Bulletin No.: 20760E
Date: September 2018

PRODUCT SAFETY RECALL

SUBJECT: Brake Pedal Pivot Nut/Bolt Loose

MODELS: 2015 - 2016 Chevrolet Silverado Crew Cab LD with Special Services (RPO 5W4)
2015 - 2016 Chevrolet Silverado HD
2015 - 2016 Chevrolet Tahoe PPV (RPO 9C1)
2015 - 2016 Chevrolet Tahoe with Special Services (RPO 5W4)
2015 - 2016 GMC Sierra HD

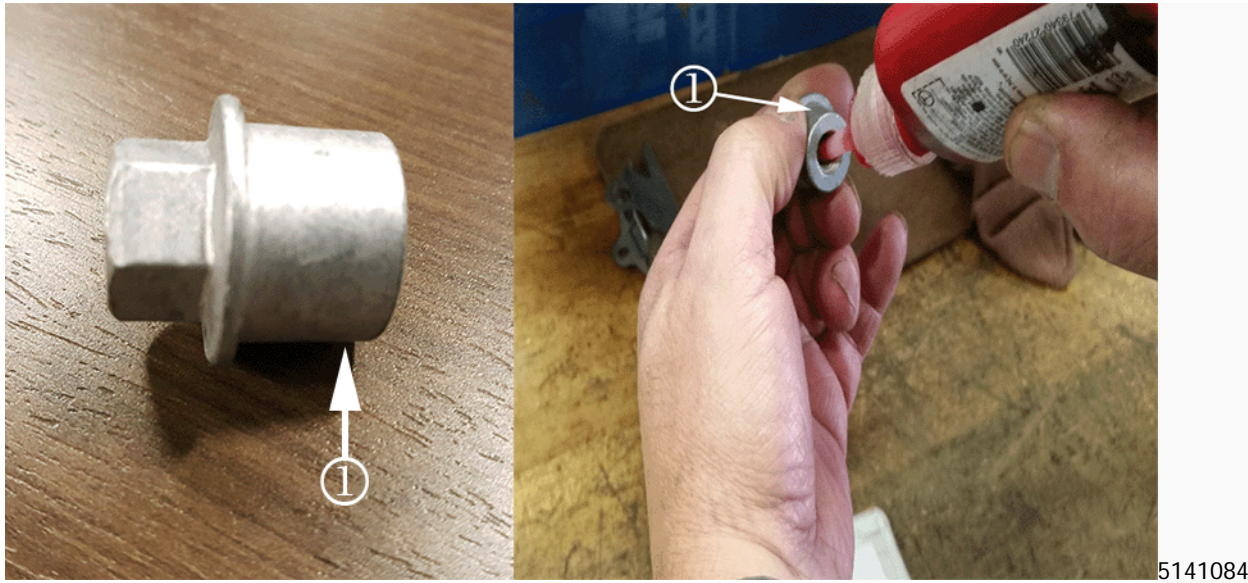
4. Holding the brake pedal pivot bolt (2) with a box end wrench, remove the brake pedal pivot nut (1).

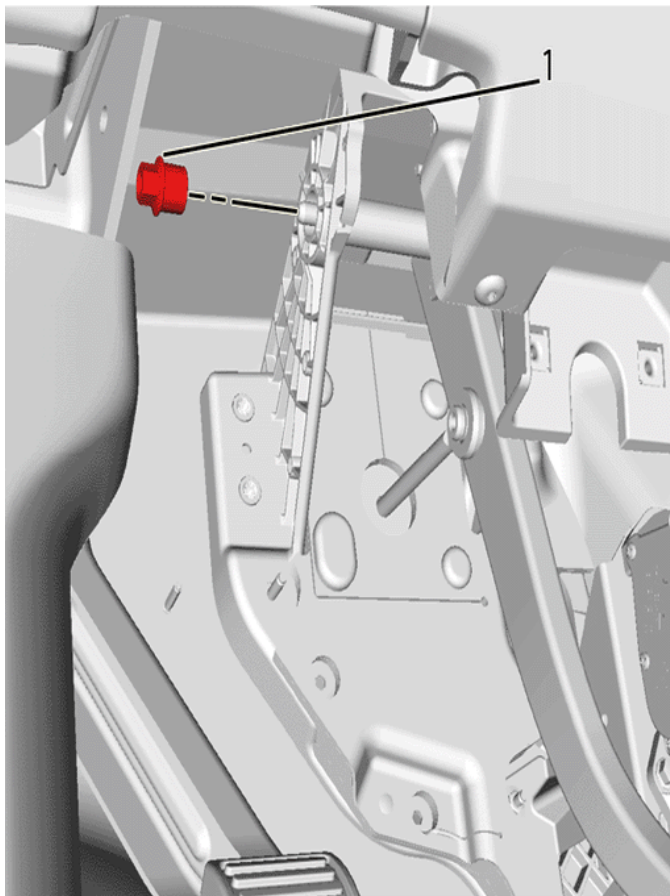
Note: Do NOT get threadlocker on the exterior of the brake pedal pivot nut. The exterior of the brake pedal pivot nut must be kept clean of threadlocker.

- 5. Holding the nut horizontally, apply two drops of red threadlocker to the threads in the collar portion (1, opposite the hex end) of the nut.

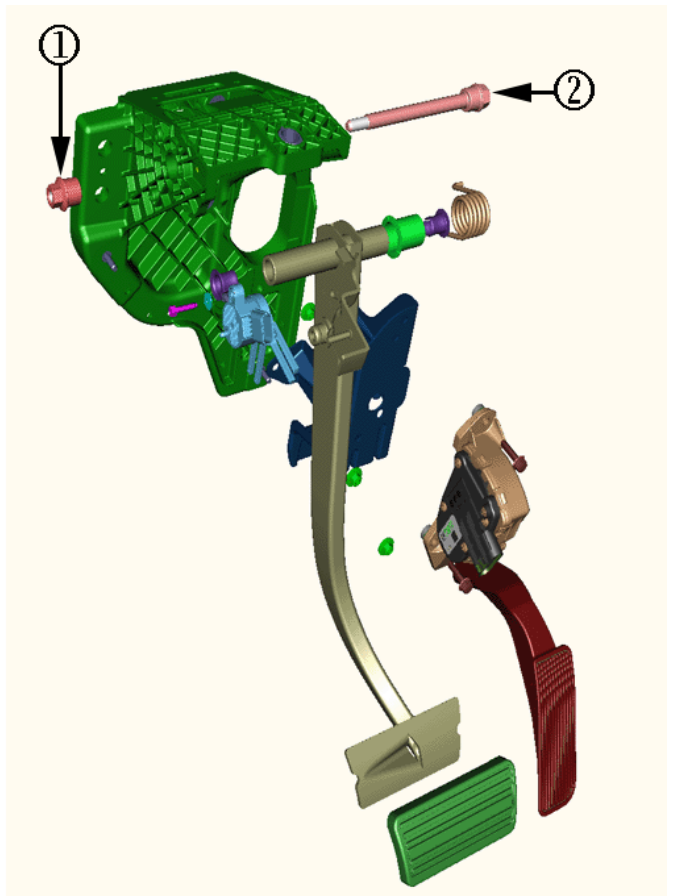
Caution: Apply pressure to the brake pedal pivot bolt while installing the nut to ensure the bolt does not back out of the housing. Part damage could occur if the bolt backs out of the housing.

6. Holding the brake pedal pivot bolt (2) with a box end wrench, install the brake pedal pivot nut (1).
7. Holding the brake pedal pivot bolt with a box end wrench, torque the brake pedal pivot nut to 26 Nm (19 lb ft).
8. On vehicles equipped with a manual transmission, install the clutch pedal, then proceed to step 11. Refer to *Clutch Pedal Replacement* in SI.
9. Install the Floor Front Air Outlet Duct - Left Side. Refer to *Floor Front Air Outlet Duct Replacement - Left Side* in SI.
10. Install the Instrument Panel Knee Bolster. Refer to *Instrument Panel Knee Bolster Replacement* in SI.
11. For all vehicles, perform the brake pedal position sensor relearn procedure. Refer to *Brake Pedal Position Sensor Calibration* in SI.
